AGENDA ITEM

Docket LU-16-0030: Boulder County - Fourmile Canyon Creek Restoration

Request: LISU application to undertake a stream restoration project on Fourmile Canyon Creek involving 12,530 cubic yards of earthwork.

GRADE CONTROL LOG J-HOOK VANE

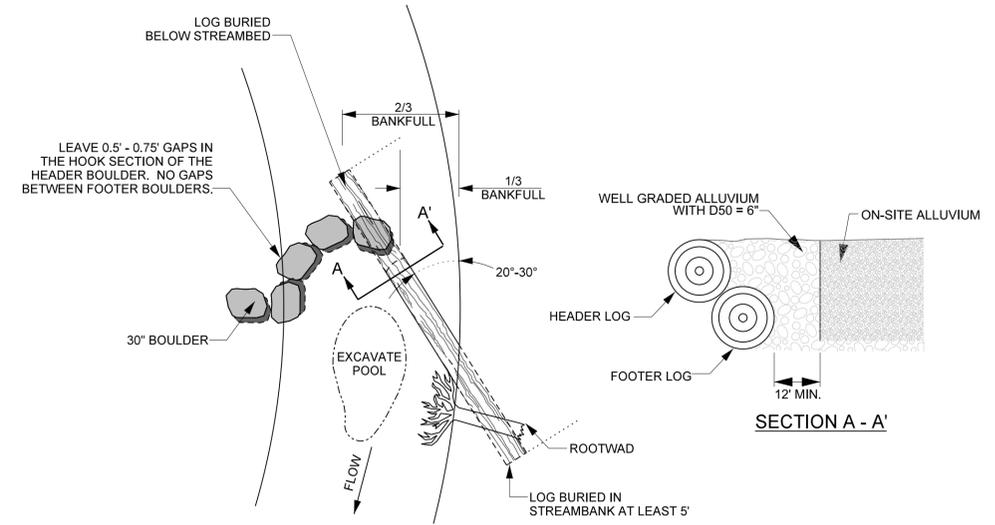
Drawing, Sheet 2B – The Log J-hook Vane detail notes that "hardwood" is to be used, whereas hardwood is not called out for any other structures that include logs. Is this correct, and if so what type of hardwood would be used and from where secured? Most stream projects are using ponderosa pine, a softwood. Some of the other details call for "brush;" what is this and where does it come from?

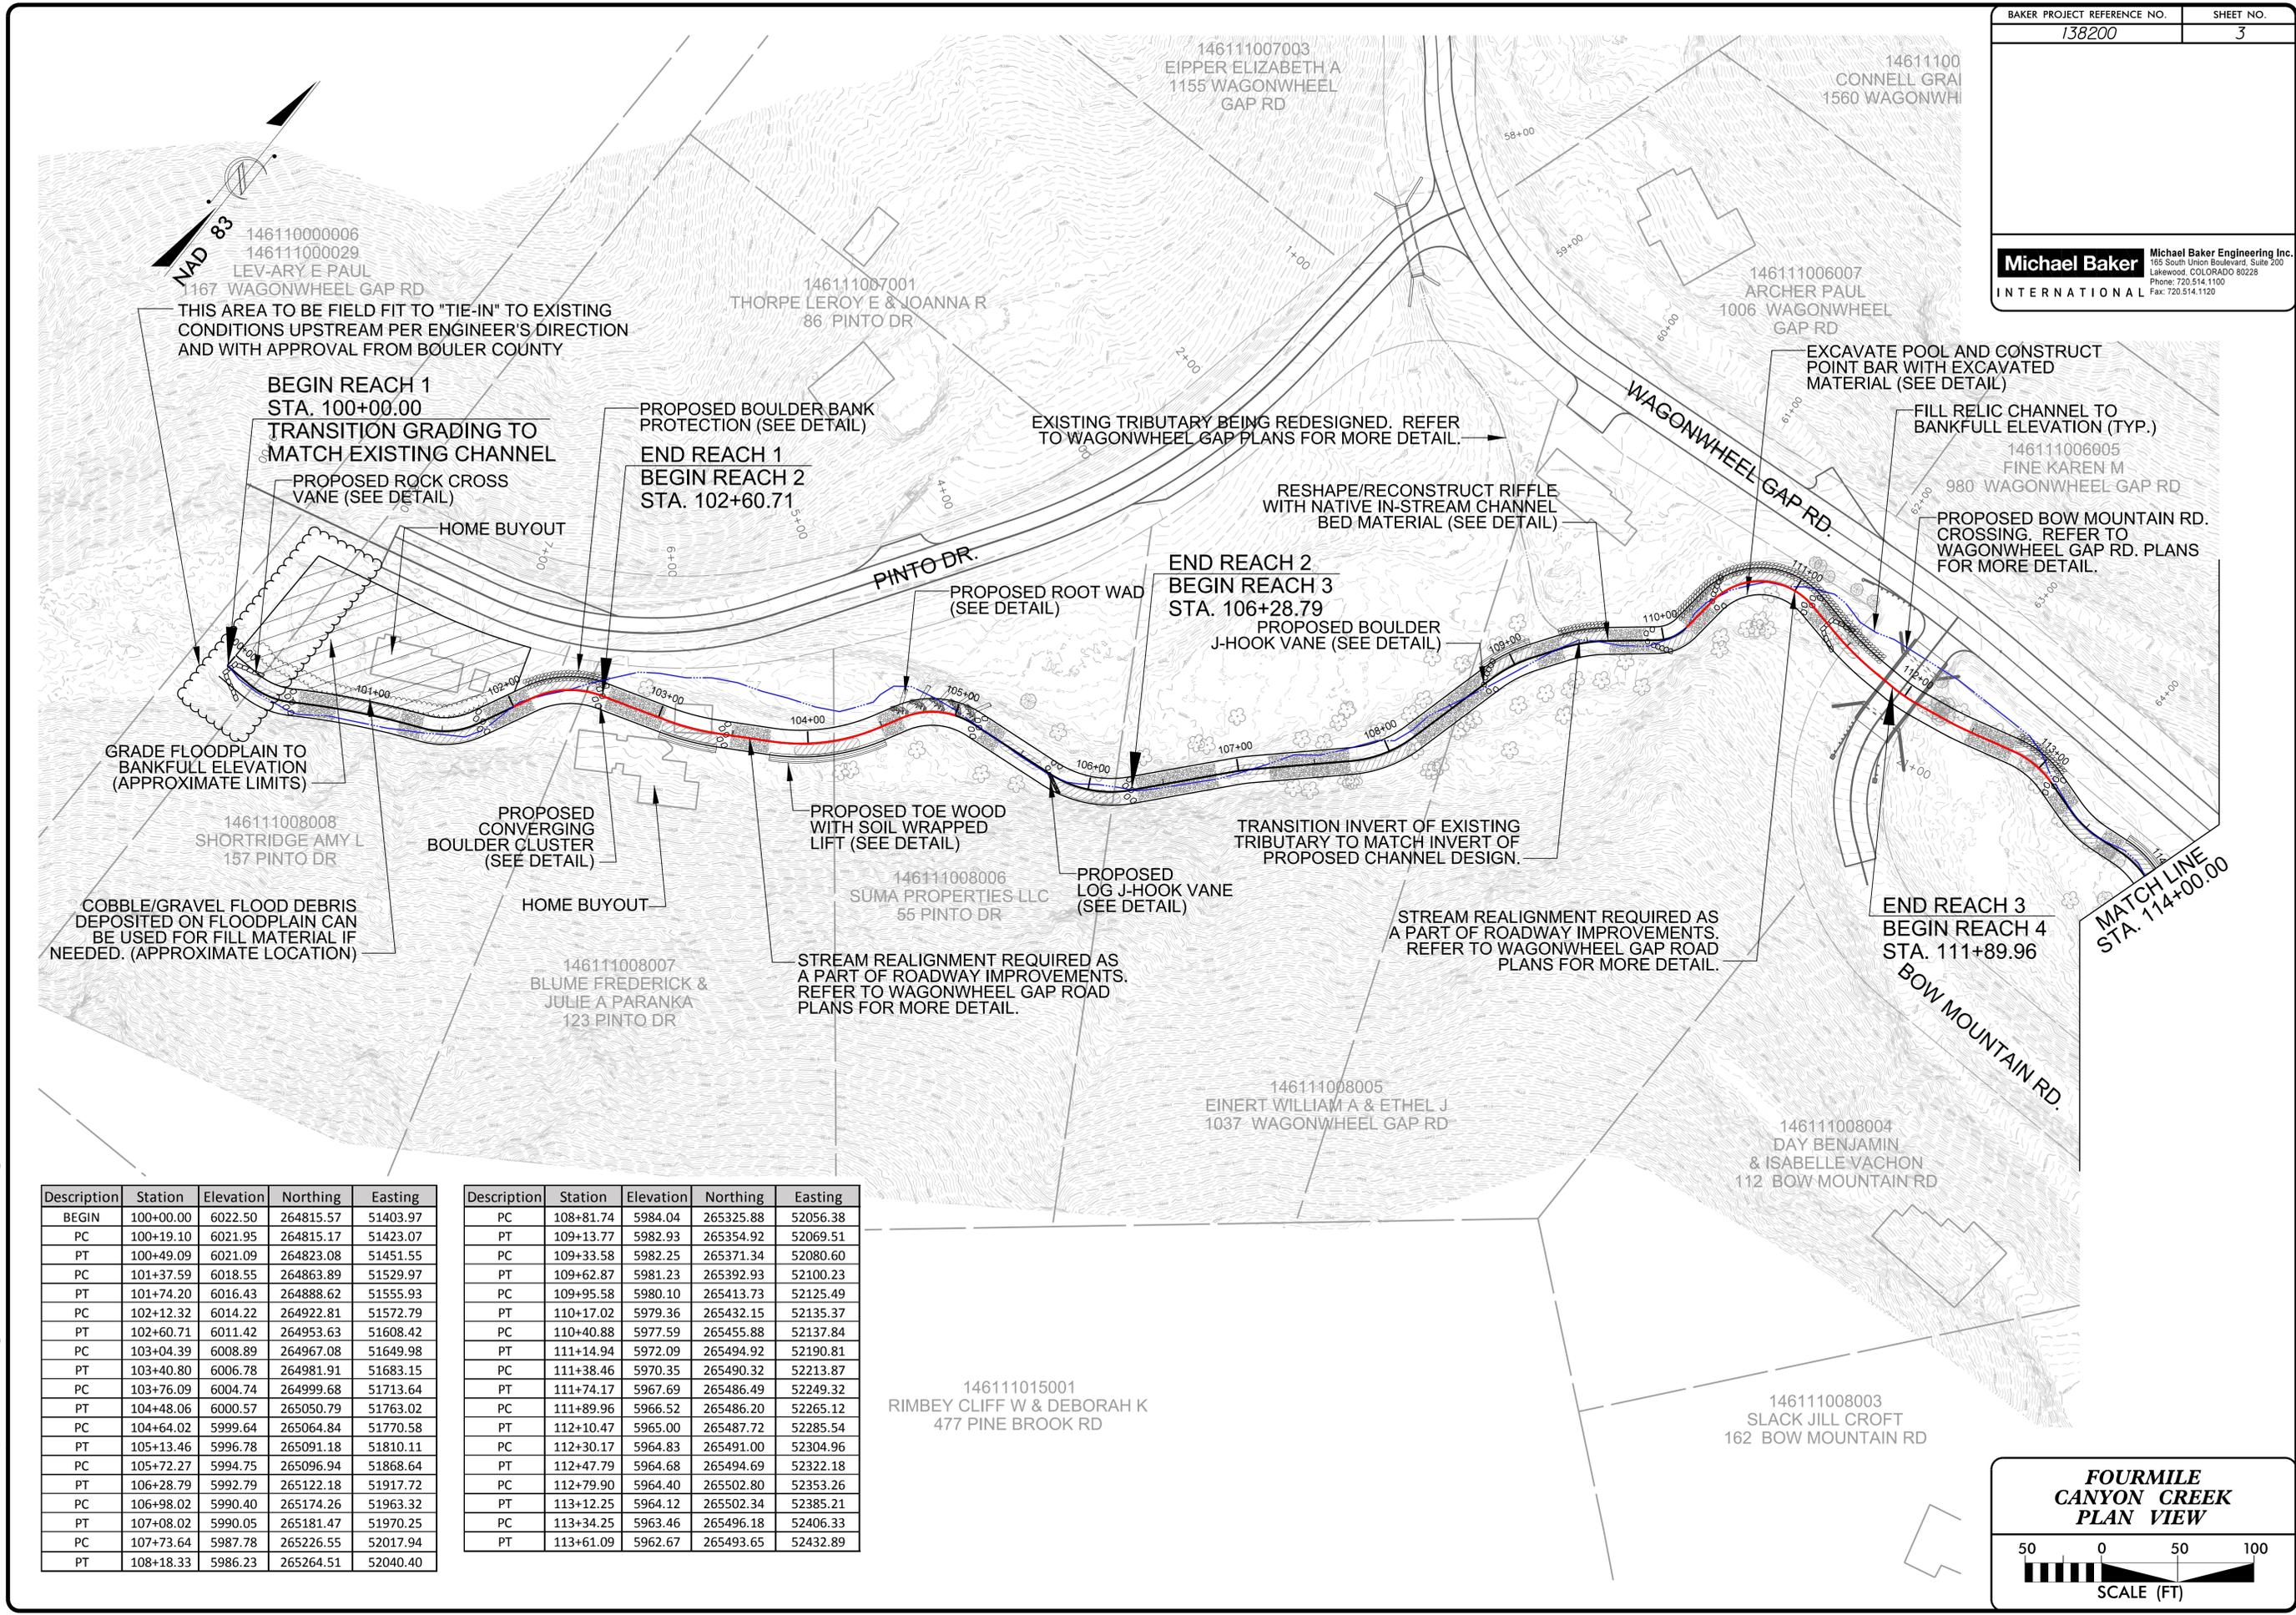
Drawings, Sheet 3 -- The area between Stations 100 and 102 calls for "grade floodplain to bankfull elevation." This aspect of the project should be coordinated with the Parks & Open Space Department. If the buy-out is closed on this property, POS is interested in the possibility of expanding parking at the destroyed Anne U. White Trailhead.

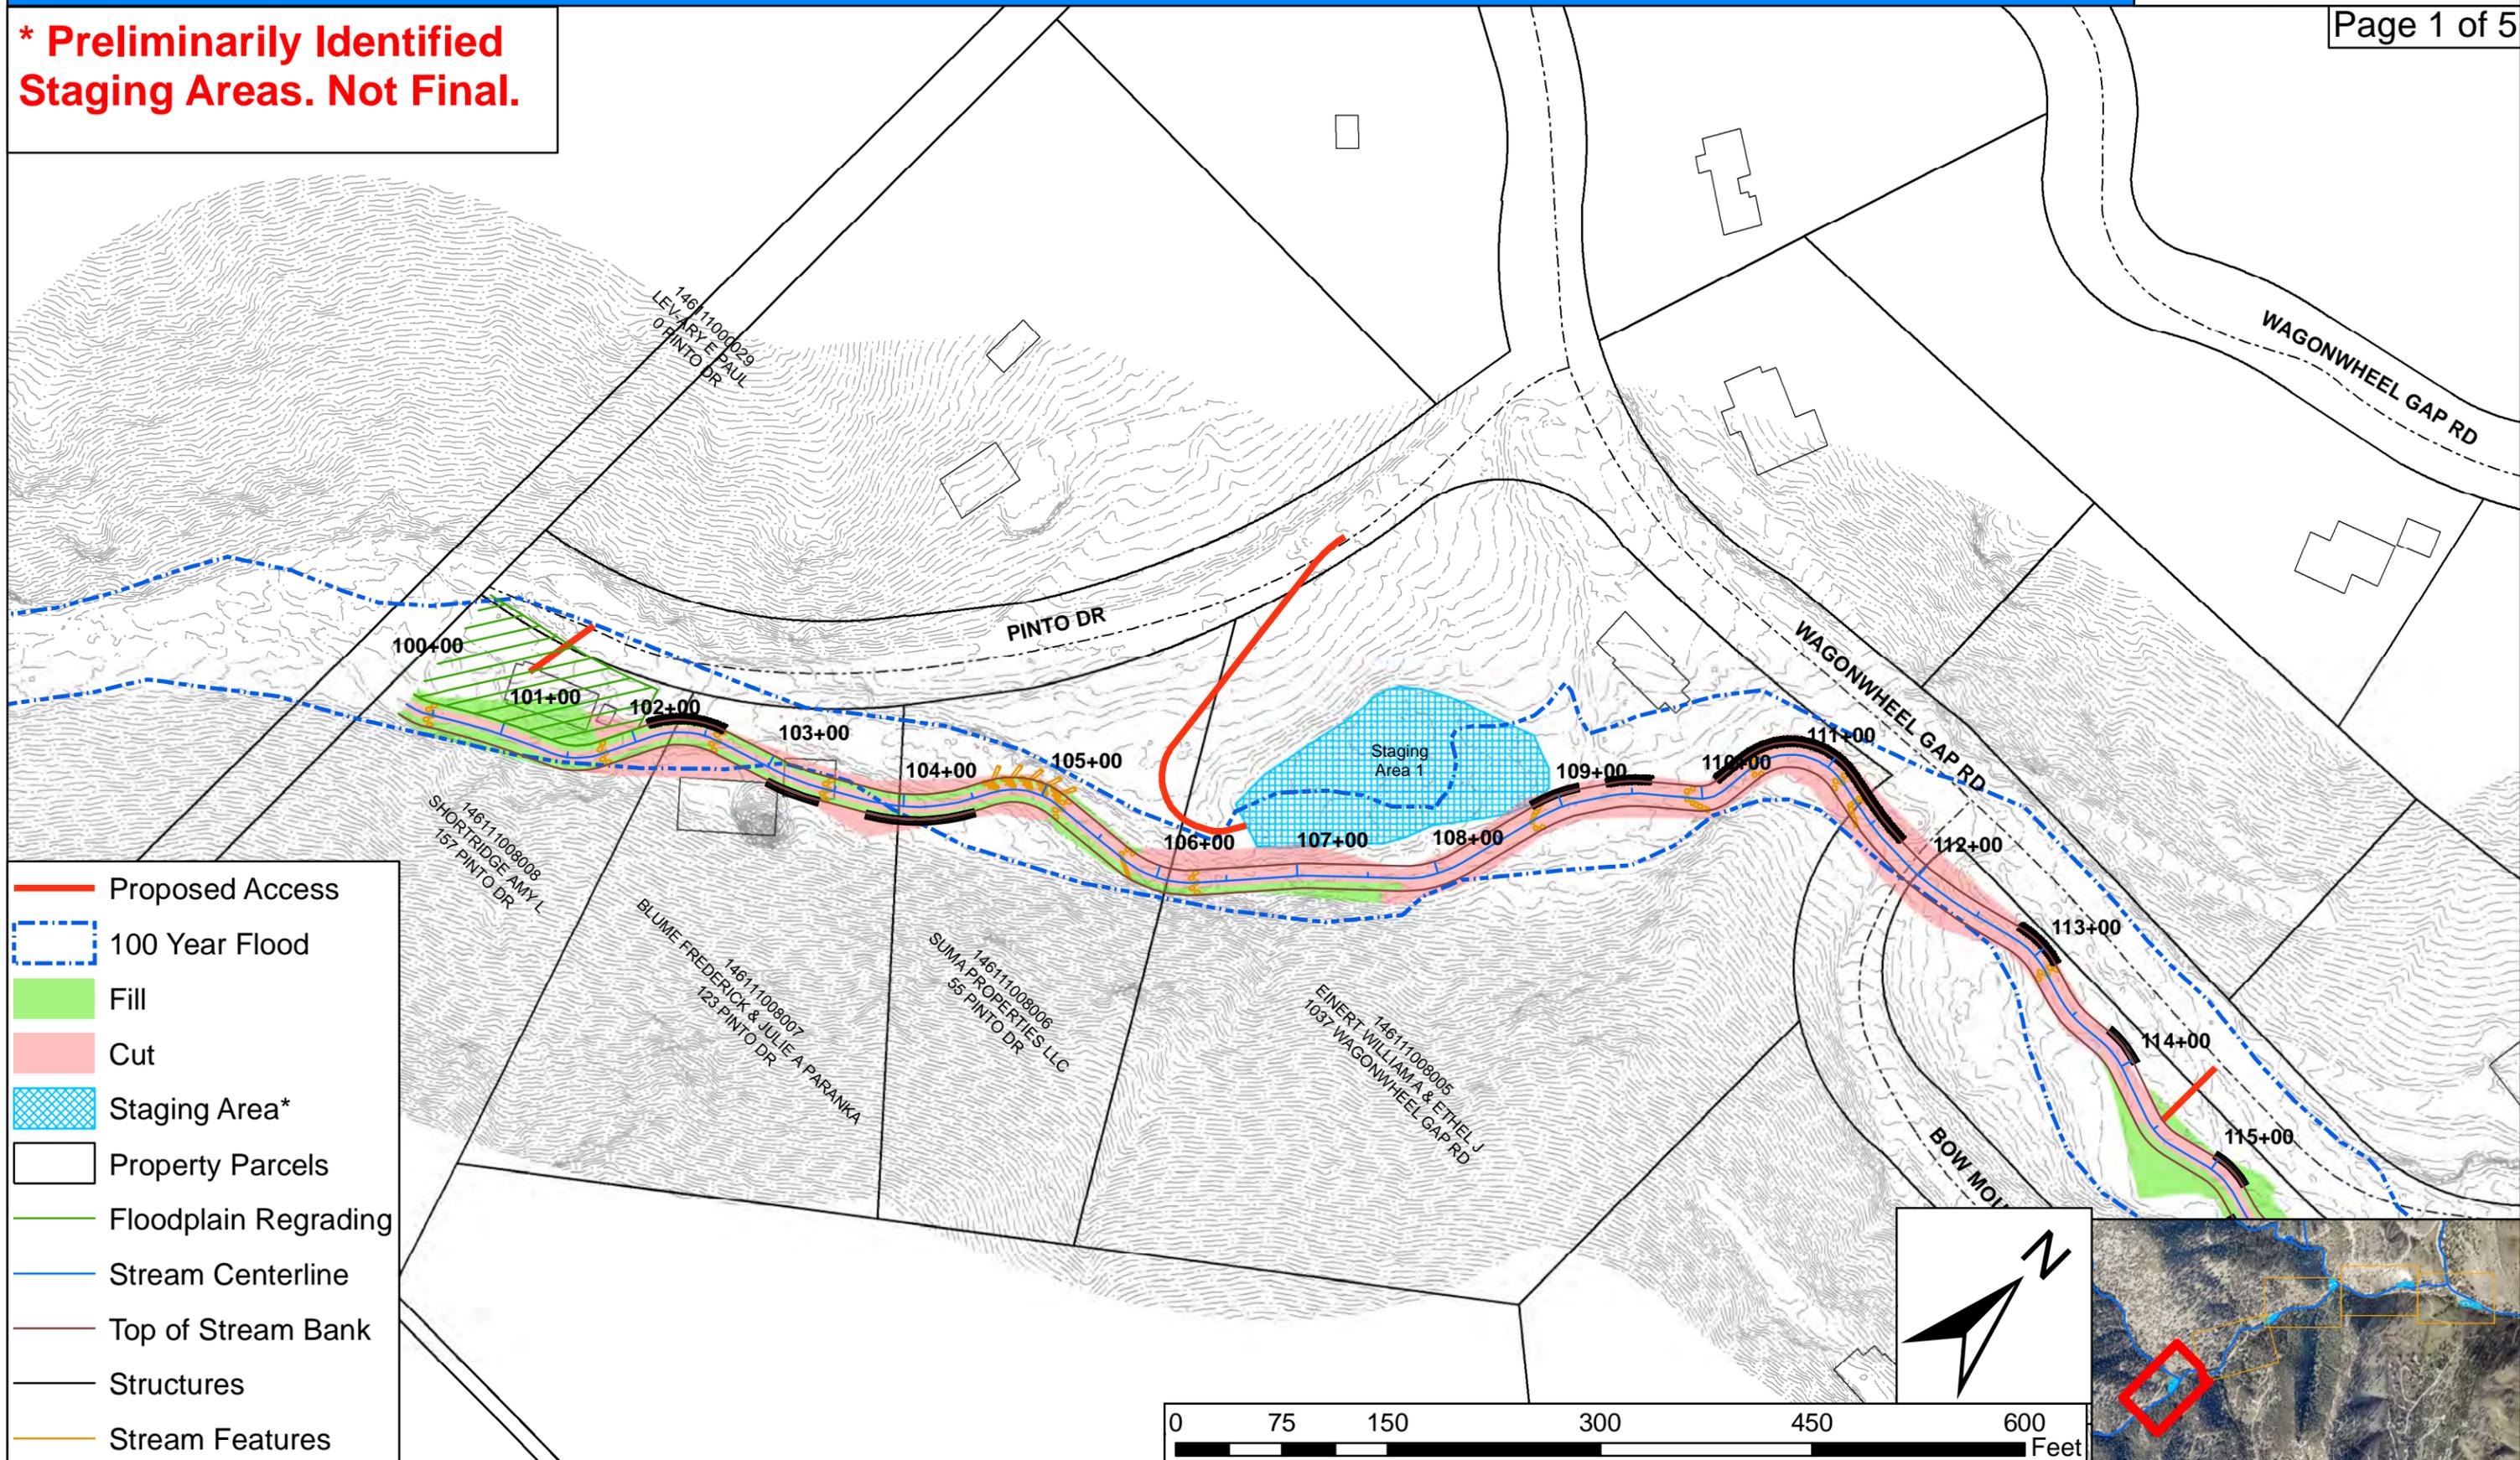
Drawings, Sheet 11, Revegetation – The following species are not native to Boulder County and cannot be included in the Revegetation Plan: *Festuca idahoensis*, *Pseudoroegneria spicata*, *Achillea millefolium*, and *Penstemon strictus*. *Elymus lanceolatus* (thickspike/streambank wheatgrass) could be used instead of *P. spicata*; the latter is a Western Slope species. The yarrow must be *A. lanulosa*; *A. millefolium* is European. *F. saximontana* could be used instead of *F. idahoensis*; the latter is a subalpine species. One of several native penstemons could be used instead of *P. spicata*.
